# UNITED STATES PATENT AND TRADEMARK OFFICE

APPLICATION NO.	FILING DATE	FIRST NAMED INVENTOR	ATTORNEY DOCKET NO.	CONFIRMATION NO.
10/647,568	08/25/2003	Alexis C. Weber	DP-310020	3258
22851	7590	03/24/2005	EXAMINER	
DELPHI TECHNOLOGIES, INC.			NGUYEN, TUAN N	
M/C 480-410-202			ART UNIT	
PO BOX 5052			PAPER NUMBER	
TROY, MI 48007			3751

<b>Office Action Summary</b>	<b>Application No.</b>		<b>Applicant(s)</b>	
	10/647,568		WEBER ET AL.	
	<b>Examiner</b>		<b>Art Unit</b>	
	Tuan N. Nguyen		3751

## DETAILED ACTION

bobbin is keyed to secondary plate

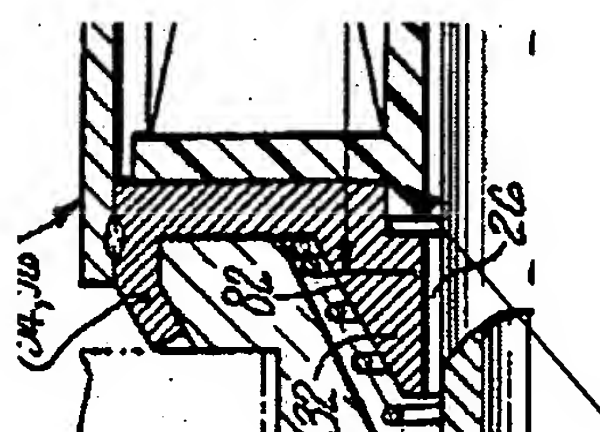
In regard to claim 1, Perach discloses a tubeless actuator comprising a frame (40), a primary plate (42,44) disposed within the frame; a secondary plate (34,36) disposed within the frame opposite the primary plate; and a bobbin (38) disposed within the frame between the primary plate and the secondary plate; and wherein the bobbin is keyed to the secondary plate to maintain alignment between the bobbin and the secondary plate (see picture below).

annular rib engages the annular groove

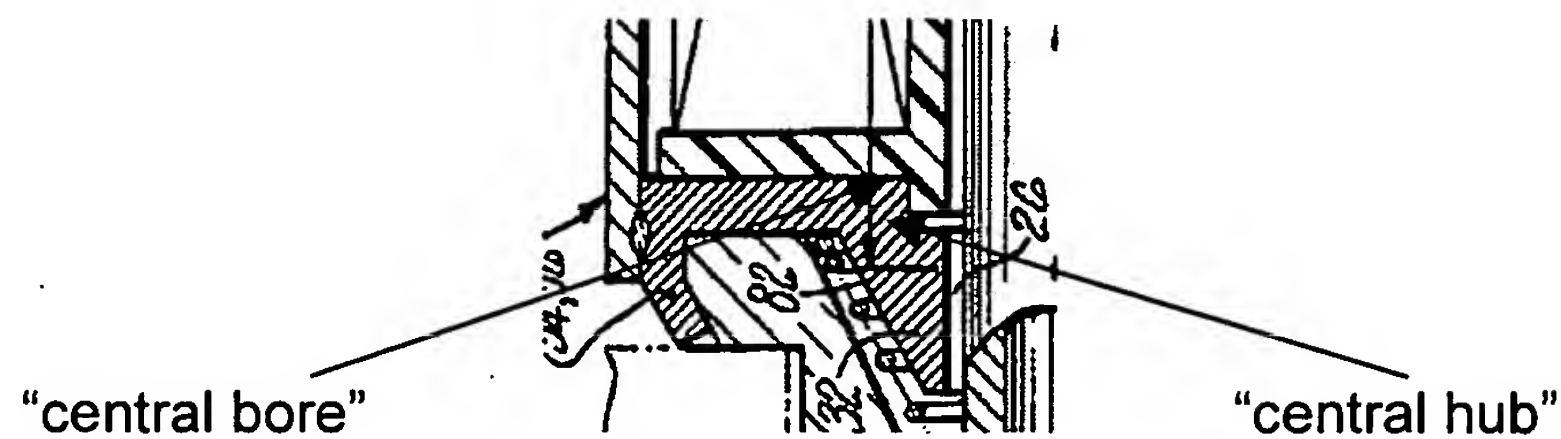
In regard to claims 6 and 22, the tubeless actuator further comprises an annular rib extending from the bobbin, an annular groove established by the secondary plate, and wherein the annular rib engages the annular groove to maintain alignment between the secondary plate and the bobbin (see picture below).

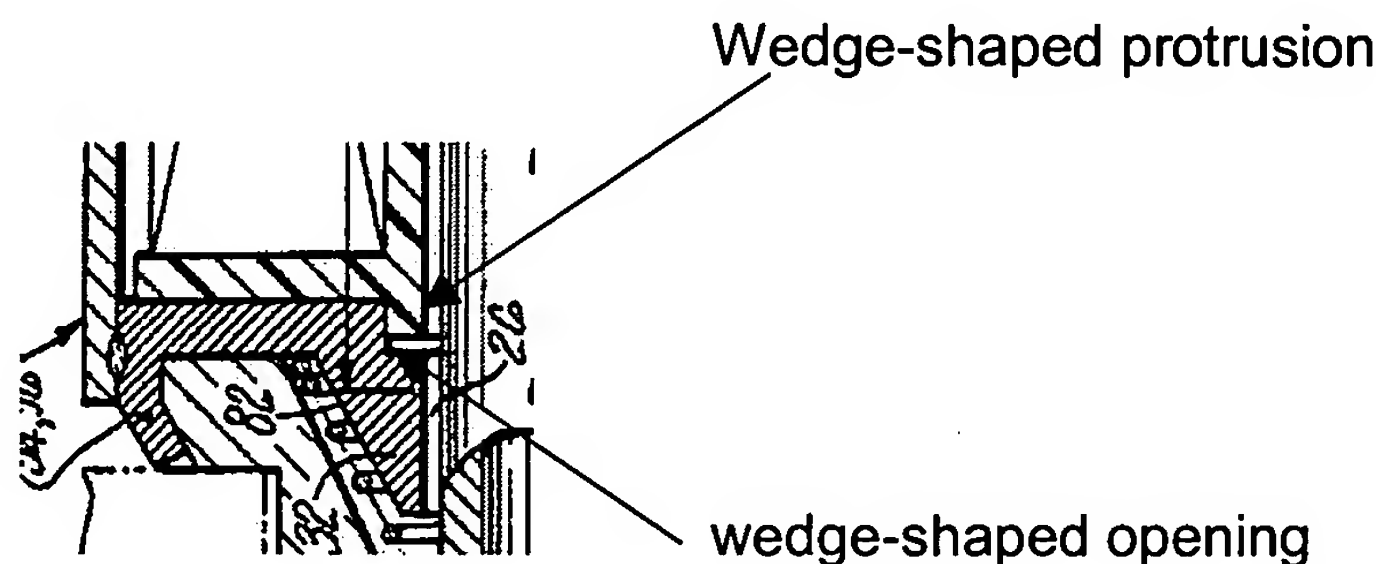
In regard to claims 7 and 23, the tubeless actuator further comprises a "central bore" established by the bobbin; a "central hub" extending from the secondary plate; and wherein the "central hub" engages the "central bore" to maintain alignment between the secondary plate and the bobbin (see picture below).
